A614/Mickledale Lane, Bilsthorpe

Road Safety Audit Stage 1 - Completion of Preliminary Design

SA2501A
October 2021

Location: 3.6 – Eastern footway of new road.

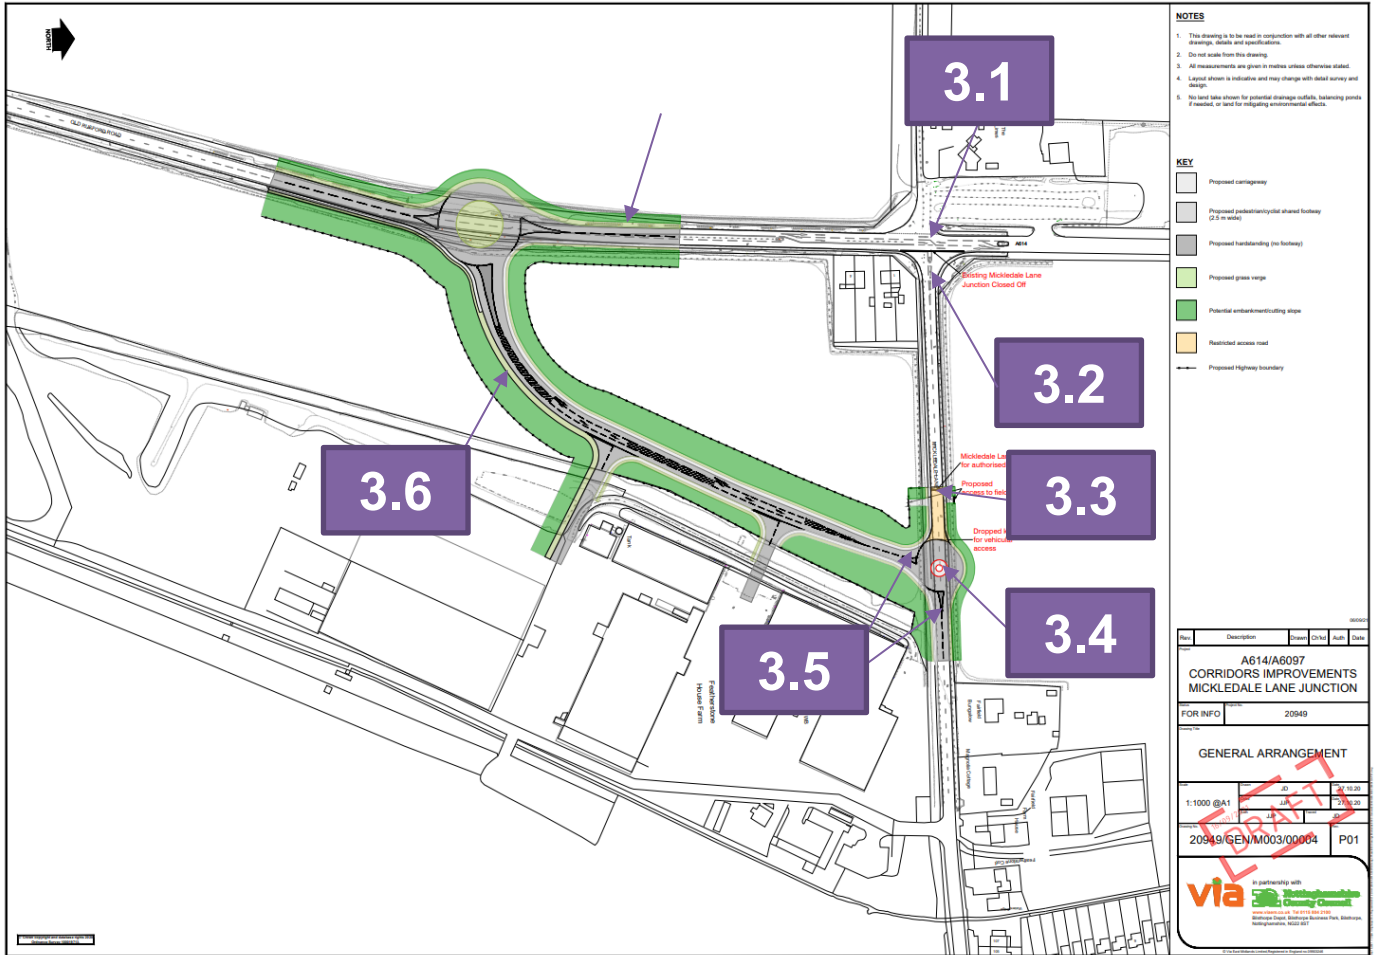
Summary: Vehicles colliding with pedestrians or cyclists.

There is a missing section of footway/cycleway, between the roundabout and the new access closest to the roundabout. Any pedestrians/cyclists wanting to travel on this section would have to do so on the verge, where they may slip, or in the carriageway where they are vulnerable to being hit by a vehicle. Pedestrians and cyclists could be injured in these collisions.

Provide footway/cycleway on this section.
